## Service Information

CL 46532022.015  
220294

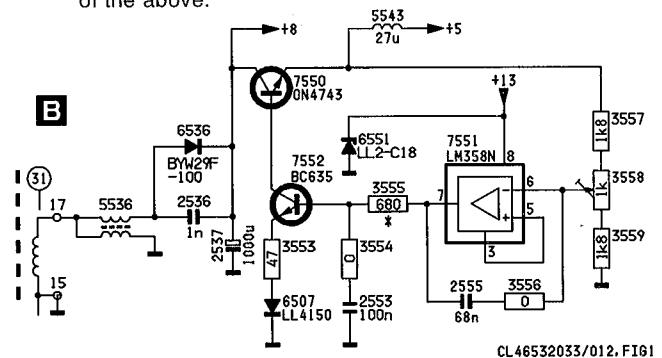
In week 9405 the picture tube of the 25" sets was changed from an A59EAK252X43 (4822 131 20501) to an A59EAK252X44 (4822 131 20602). These picture tubes have a different deflection unit. This modification has been introduced in sets with a serial number beginning with AG12 or higher. At the same time as the introduction of this modification the following components on the LSP have also been modified:

- 2504 and 2505 are now 270pF (4822 122 20054)
- 2520 is now 390pF (4822 121 51527)
- 3504 and 3506 are now 1 $\Omega$ 2 (4822 053 11128)
- 3602 is now 22k (4822 100 11213)
- 3603 is now 10k (4822 051 10103)
- for -/19 sets 3603 is now 6k8 (4822 051 10682)
- 3633 is now 150k (4822 051 10154)

CL46532033/012.FIG2

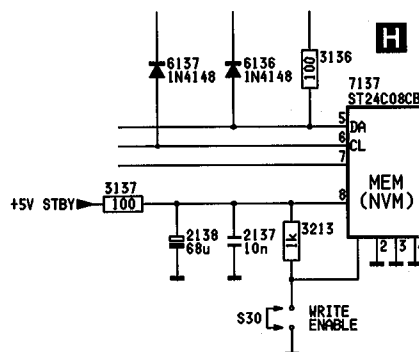
The difference between the old and the new SSP is as follows (see figure below):

- Position S30 pin strip 3P added (4822 265 31009)
- Position 3213 1kΩ added (4822 051 10102)
- Position 4127 jumper added (4822 051 10008)
- Positions 4135 and 9228 removed
- Position 7137 modified to ST24C08CB1 (4822 209 32283)

S30 = OPEN: READ ONLY SERVICE SETTINGS  
S30 = CLOSE: READ/WRITE SERVICE SETTINGS
